PLAN NO. 27
- 10-10-25

AMENDED.
ARRANGEMENT FOR FILLING IN AFTER WELL.
S.S. DORIC STAR.

"DORIC STAR"

Report No. 90974

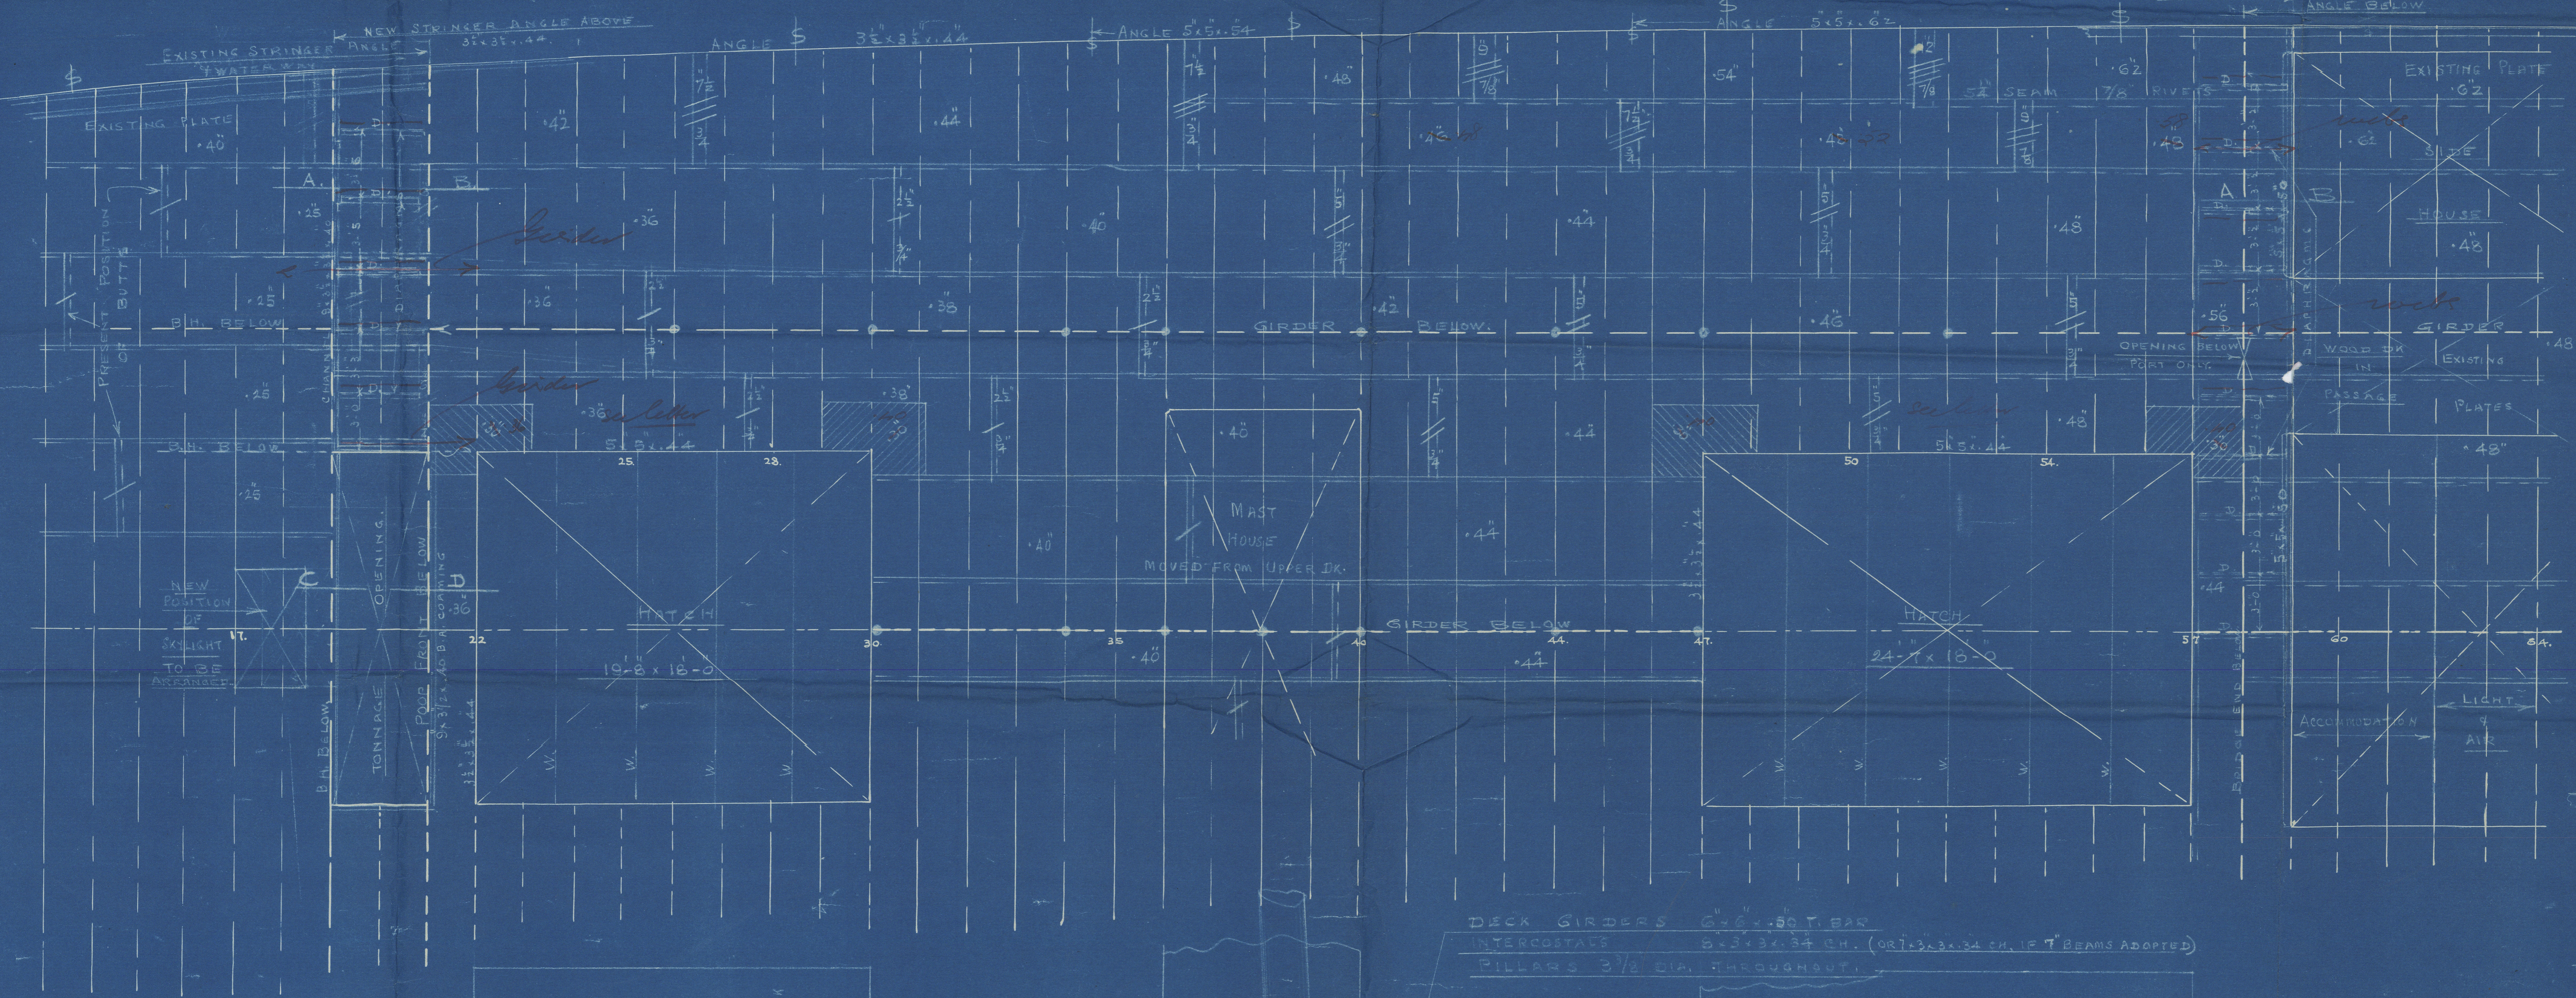
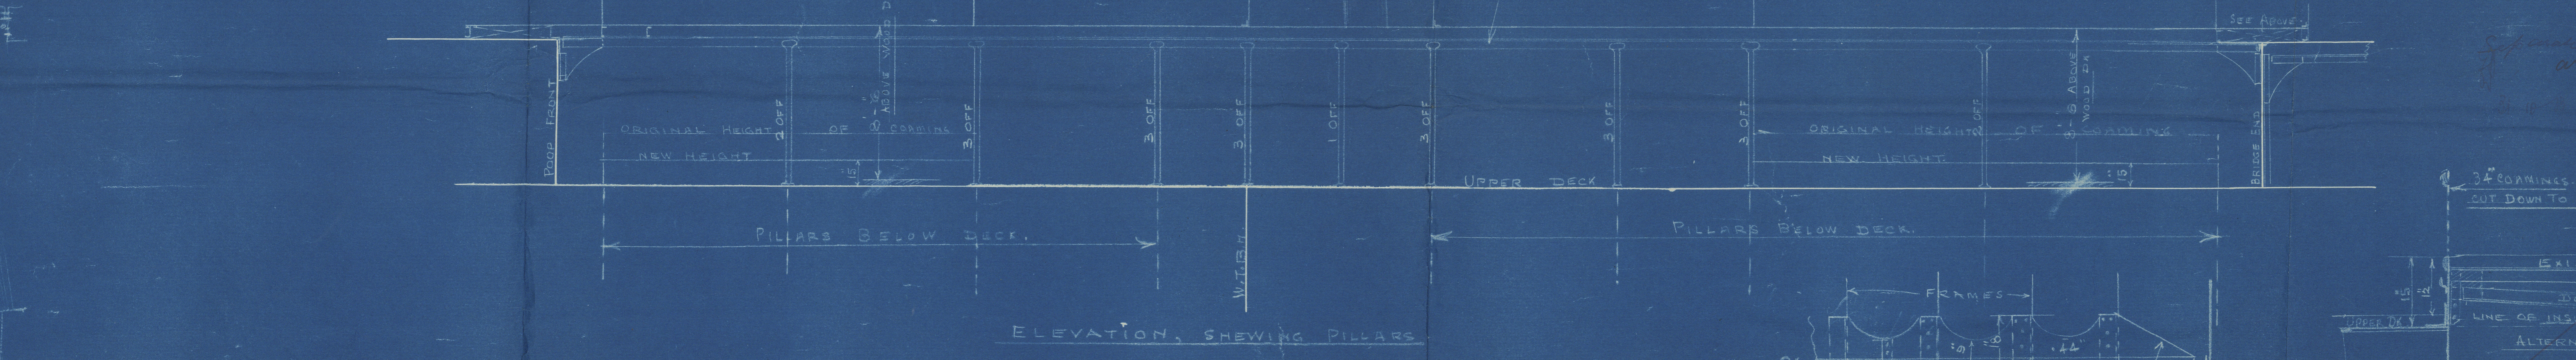
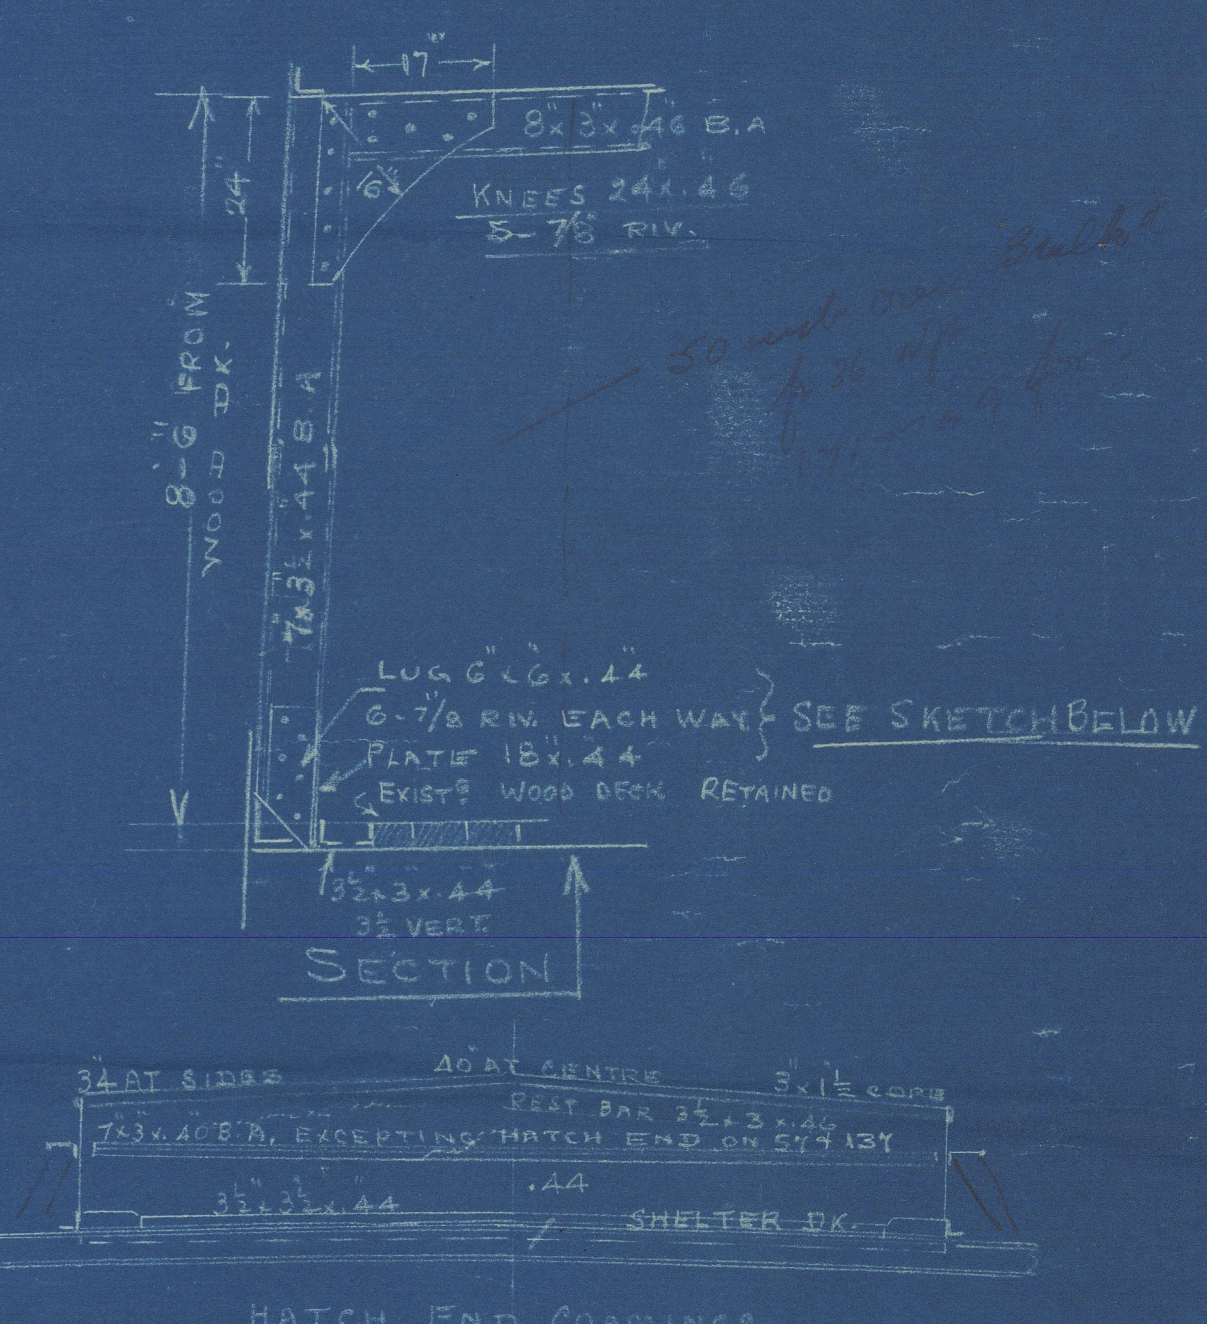
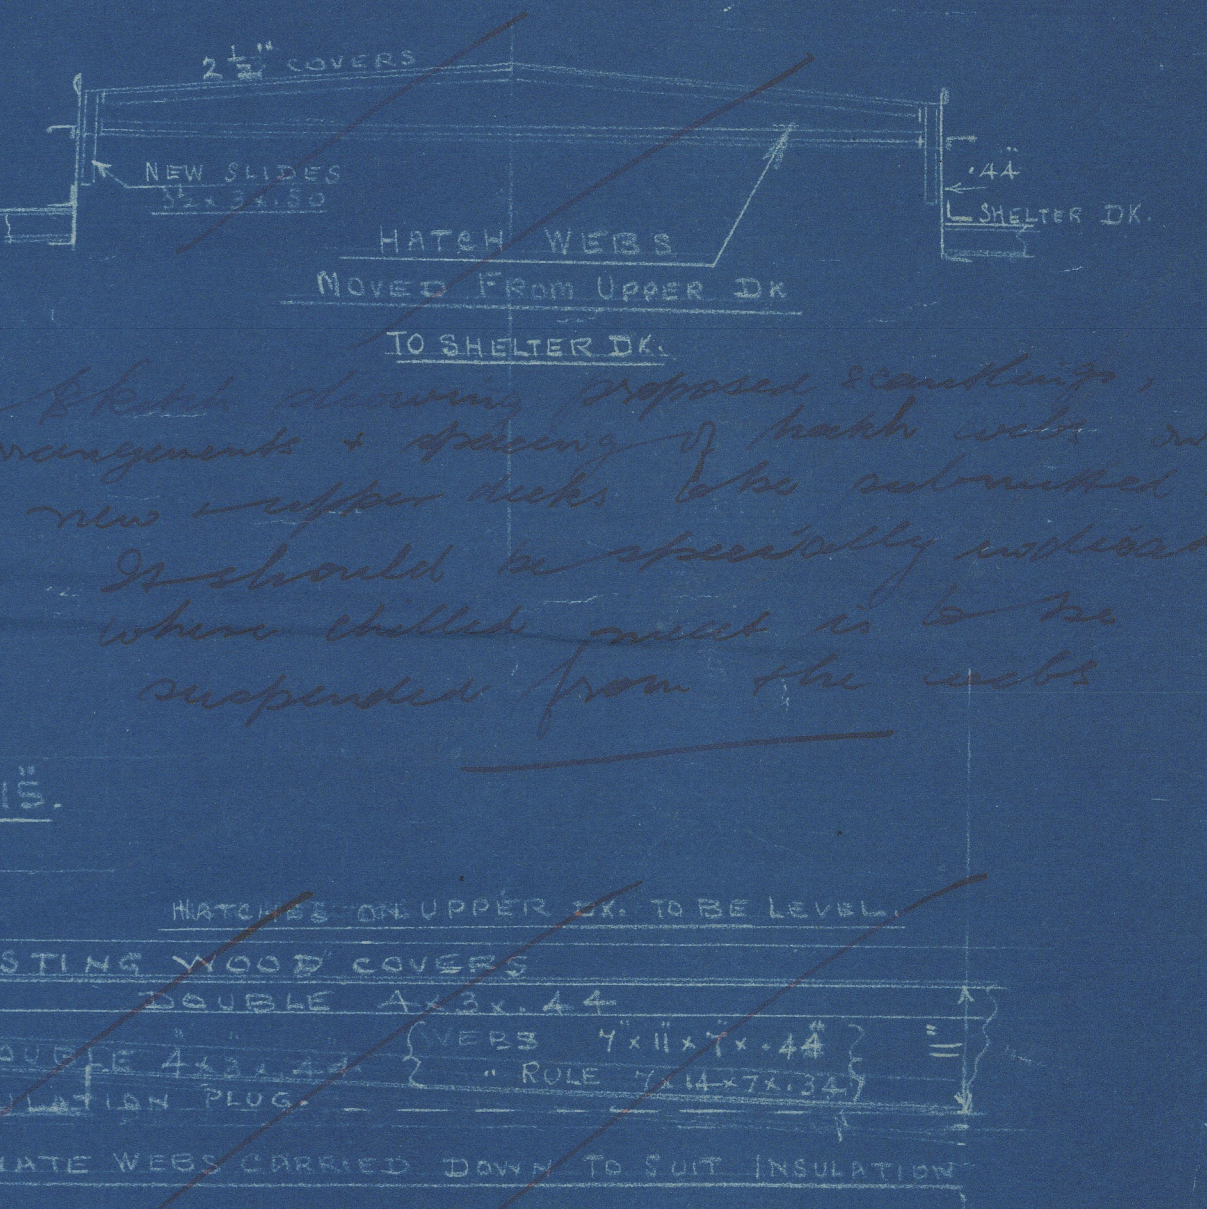
Separate plan showing proposed arrangement of hatch with new upper deck also submitted. It should be specially indicated where shells failed to be suspended from the ribs.
